2024/2614/P

34 Parkhill Road, London, NW3 2YP

Delegated Report (Members Briefing)		Analysis sheet		Expiry Date:		21/08/2024	
		N/A		Consultation Expiry Date:		28/07/2024	
Officer				Application Number			
Henry Yeung				2024/2614/P			
Application Address				Drawing Numbers			
Flat C 34 Parkhill Road London NW3 2YP				See draft decision notice			
PO 3/4	Area Team Signature	C&UD	Authorised Officer Signature				
Proposal(s) Erection of a ground floor side and rear wraparound extension, and the installation of 4 rooflights on the proposed extension.							
Recommendation(s):		Grant Conditional Planning Permission					
Application Type:		Full Planning Permission					
Conditions or Reasons for Refusal:		Refer to Draft Decision Notice					
Informatives:							
Consultations							
Adjoining Occupiers:				No. of responses	01	No. of objections	01
Summary of consultation responses:		A Site Notice was displayed at the site from 03/07/2024 until 27/07/2024 and a Press Notice was published from 04/07/2024 and 28/07/2024. One objection was received from the Parkhill CAAC as outlined below. No other responses were received during the statutory consultation period.

Image 1 – Aerial view showing the property on the edge of Parkhill Road at the rear

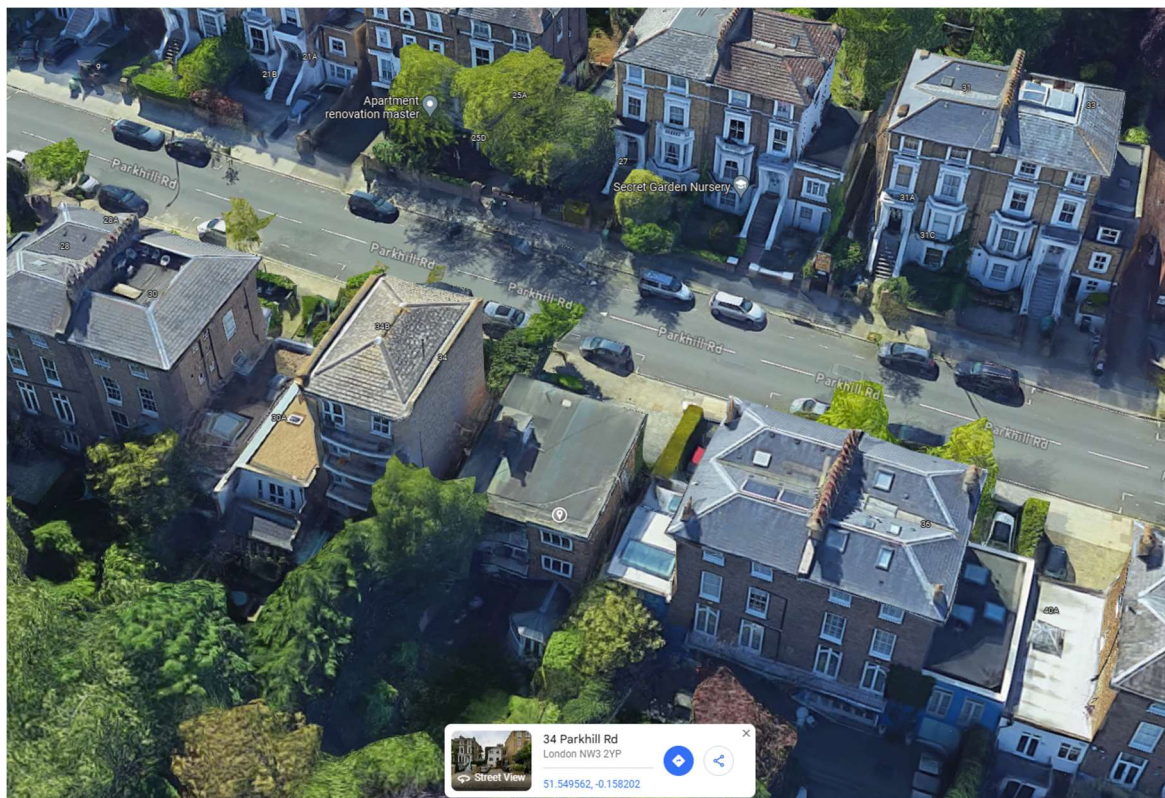
The site is located on the eastern side of Parkhill Road and pertains to the lower ground floor flat within 34 Parkhill Road. This flat is part of a large semi-detached building comprising self-contained flats across three floors. Due to the local topography, the rear garden of the site is situated at the lower ground floor level. The building also features an existing balcony at the upper floors on the rear. The site is within the Parkhill Conservation Area, to which it makes a neutral contribution. The property is not a statutorily listed nor locally listed building. The conservation area includes many mature trees between the rear gardens. The site contains a tree subject to a Tree Preservation Order (TPO) within the rear garden.
